**Office of Engineering and Technology**[OET Home Page](#)[FCC](#) > [FCC E-filing](#) > [Inquiry System Home Page](#) > View Inquiry[FCC Site Map](#)**Site Options**[Basic KDB Search](#)[Advanced KDB Search](#)[Submit an Inquiry](#)[Reply to an Inquiry Response](#)[Category List](#)[FAQ Search](#)[Major Guidance Publications](#)[Draft Laboratory Division Publications](#)[Draft Laboratory Division Publications \(Expired\)](#)[Draft Publication Moderation Policy](#)**Related Sites**[Equipment Authorization Presentations](#)[Equipment Authorization System \(EAS\)](#)[Telecommunications Certification Bodies \(TCB\)](#)[Measurement Procedures](#)**Reply to an OET Inquiry Response****Currently Displaying Inquiry Tracking Number: 730030****Contact Information:**

First category: Equipment Authorization Process *
Second category: Certification [Equipment Authorization Process]
Third category:
Subject: FCC ID Label for Cochlear Nucleus 8 Sound Processor
Inquiry:

Attachment List:[Artwork for Engraving](#)

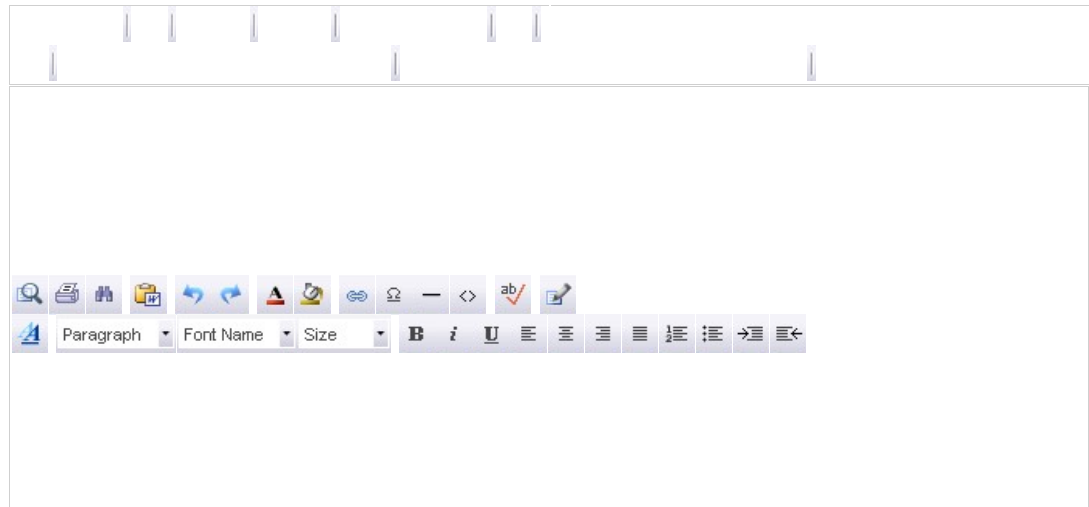
The available surface area for marking on the inner spine is very limited. As shown in the artwork for engraving attached, the unique device number (#101016XXXXXX) and build standard letter (Y), whose font sizes are smaller than four-points, have already occupied most of the inner spine surface area and thus leave no surface area for the FCC ID (WTO-CP1110).

As per section 3 of FCC General Guidelines for labelling, 84748 D01 General labelling and Notification v09r01, we plan not to mark the FCC ID on the case, instead, to include the FCC ID in the user guide and also place it either on the device packaging or on a removable label.

Please confirm if our proposal for marking is acceptable so that the TCB can proceed the certification.

Hello,
Yes, we can accept pursuant to 2.925(f) of the FCC Rules.
